UNITED STATES PATENT AND TRADEMARK OFFICE

APPLICATION NO.	FILING DATE	FIRST NAMED INVENTOR	ATTORNEY DOCKET NO.	CONFIRMATION NO.
10/760,110	01/16/2004	Marc Vincent Marini	0212.67006	7346
24978	7590	10/03/2006	EXAMINER	
GREER, BURNS & CRAIN 300 S WACKER DR 25TH FLOOR CHICAGO, IL 60606			TALBOT, MICHAEL	
			ART UNIT	PAPER NUMBER
			3722

Office Action Summary

DETAILED ACTION

Marc V. Marini SN 10/760,110 8/5/2005
Greer, Burns & Crain, Ltd., Roger D. Greer (312) 360-0080
Our File 0212.67006 Sheet 14 of 18 REPLACEMENT SHEET

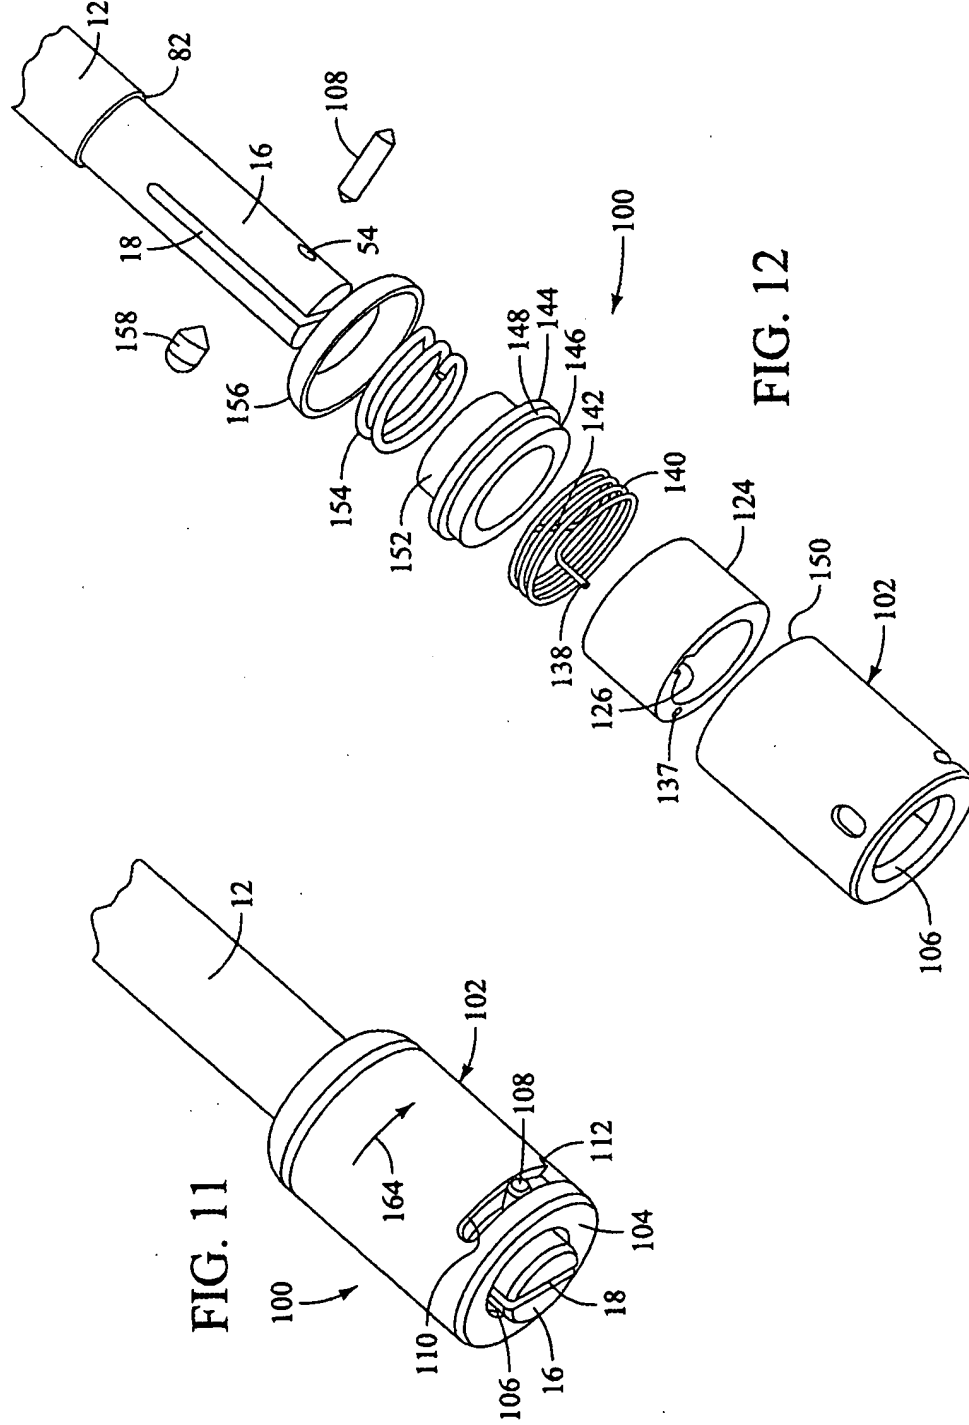
1. The drawings are objected to as failing to comply with 37 CFR 1.84(p)(5) because they do not include the following reference sign(s) mentioned in the amended description replacing paragraph beginning at page 12, line 1: "axial rib 211" described in Applicant's Amendment filed 18 August 2006 on page 4. Corrected drawing sheets in compliance with 37 CFR 1.121(d) are required in reply to the Office action to avoid abandonment of the application. Any amended replacement drawing sheet should include all of the figures appearing on the immediate prior version of the sheet, even if only one figure is being amended. Each drawing sheet submitted after the filing date of an application must be labeled in the top margin as either "Replacement Sheet" or "New Sheet" pursuant to 37 CFR 1.121(d). If the changes are not accepted by the examiner, the applicant will be notified and informed of any required corrective action in the next Office action. The objection to the drawings will not be held in abeyance.

NOTE: The above drawing objection addresses deficiencies drawn to non-elected species described in claims 15-25 and Figures 11-22 that are not being evaluated on the merits within this Office Action.

In addition to Replacement Sheets containing the corrected drawing figure(s), applicant is required to submit a marked-up copy of each Replacement Sheet including annotations indicating the changes made to the previous version. The marked-up copy must be clearly labeled as "Annotated Sheets" and must be presented in the amendment or remarks section that explains the change(s) to the drawings. See 37 CFR 1.121(d)(1). Failure to timely submit the proposed drawing and marked-up copy will result in the abandonment of the application.
